DANE COUNTY DEPARTMENT of PUBLIC WORKS, HIGHWAY and TRANSPORTATION

RFB NO. 313083 - ADDENDUM NO. 3

CONSTRUCTION OF EAST HIGHWAY GARAGE – SALT STORAGE FACILITY (BID PACKAGE A) AND MEDICAL EXAMINER OFFICE BUILDING (BID PACKAGE B)

**DEPARTMENT OF PUBLIC WORKS,
HIGHWAY & TRANSPORTATION
3562 COUNTY HIGHWAY AB
MCFARLAND, WISCONSIN**

3 Fuel Island Foundation Plan
1/8" = 1'-0"

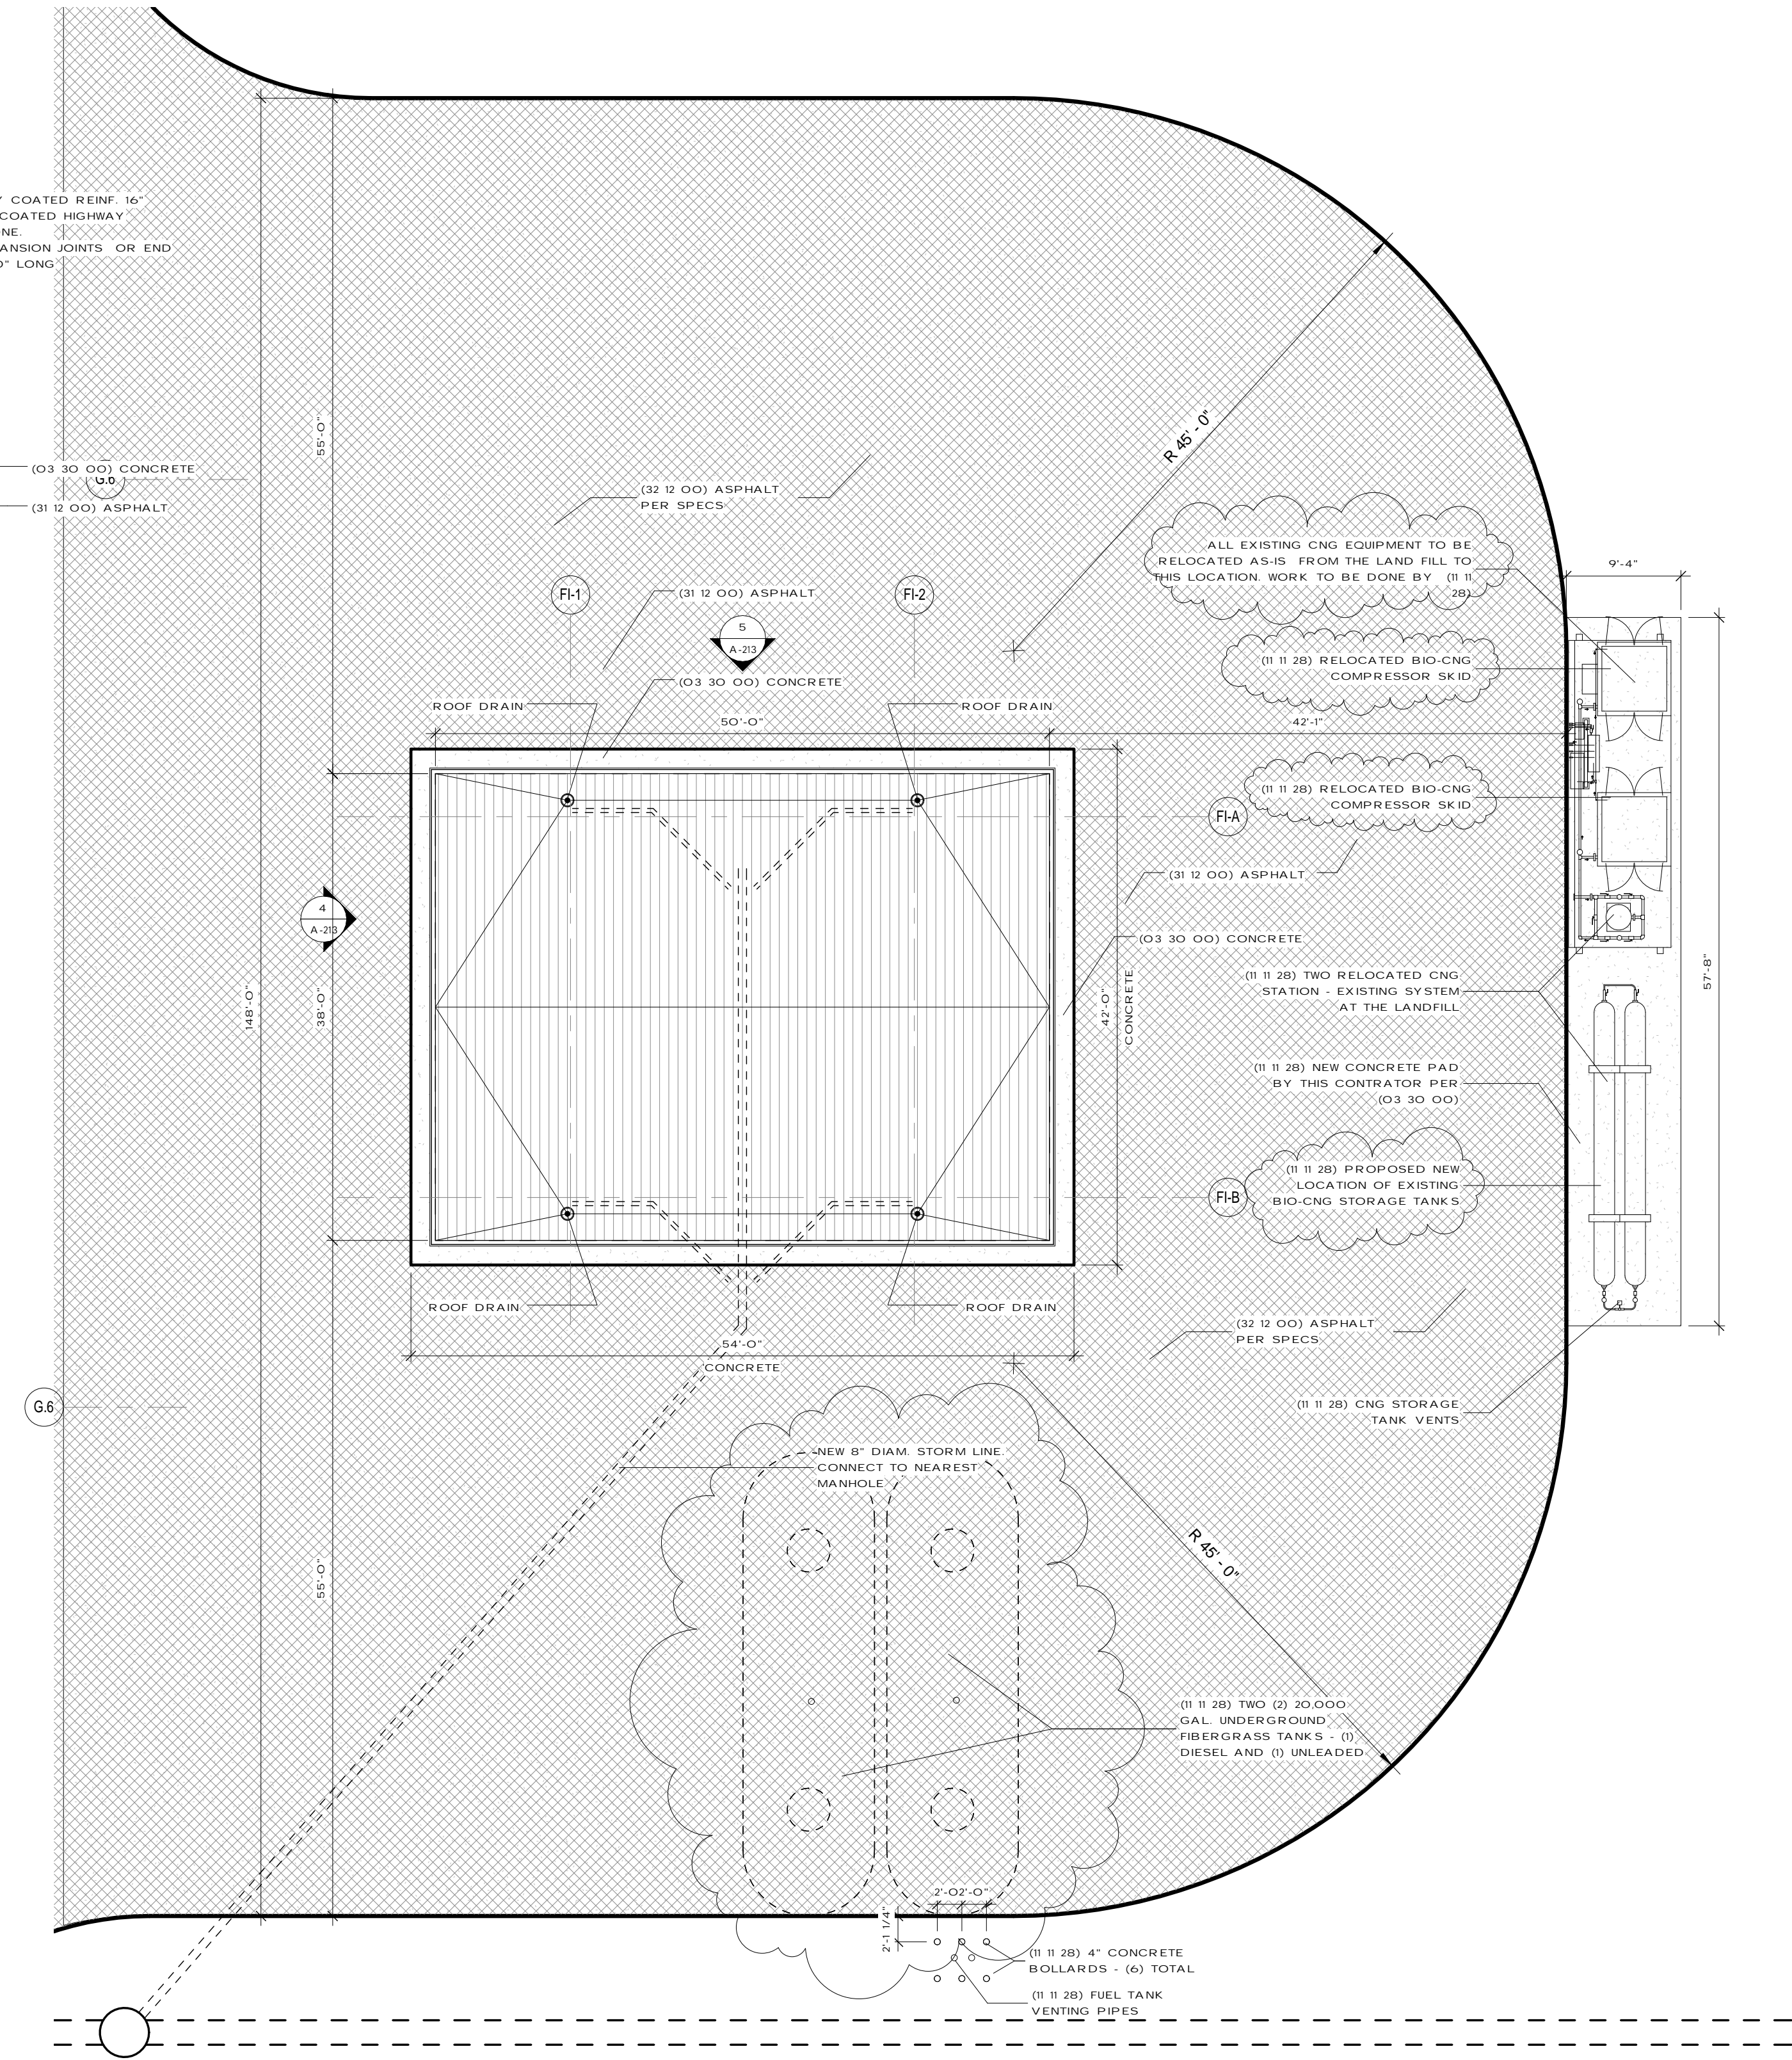
2. Paragraph 2.1 C – Specification states “Six (6) total dispensers required at the Fuel Island.” To clarify, two dispensers are for unleaded, two dispensers are for diesel, one dispenser is an existing CNG dispenser, and one dispenser is a new CNG dispenser. See Sheet A-213, revised as part of the addendum.

1. See revised sheet included in this addendum for revisions and clarifications to the fuel island area.
2. Elevations: Additional extruded canopy band shown is not necessary. A 36" flat fascia panel is acceptable. Panel color to be from manufacturer's standard range, tan or beige.
3. Underground fuel tanks have been rotated 90 degrees.
4. Install concrete pavement in the fuel island area in lieu of asphalt paving shown. See revised Sheet A-213.
5. Concrete pad under relocated CNG equipment shall be as detailed on revised Sheet A-213. The same pad detail shall apply to the backup generator pad and control panel pad.
6. Provide twelve (12) 6" pipe bollards per Detail 14/A-502 spaced equally along the edge of the CNG equipment pad to protect from traffic. Provide two (2) 6" pipe bollards at CNG Control Panel Pad. This work is to be done by the Fuel Contractor.

7. Of the two CNG dispensers shown, one shall be a new dispenser; one shall be an existing dispenser. Existing dispenser shall be relocated from the adjacent landfill.
8. Complete startup of the existing CNG system will be the responsibility of the Fuel Contractor. Any damage or disrepair as a result of the system being unused for the past twelve months will not be the responsibility of the Fuel Contractor.
9. Natural Gas service with a separate meter will be provided to the fuel island area as shown on Sheet A-213.
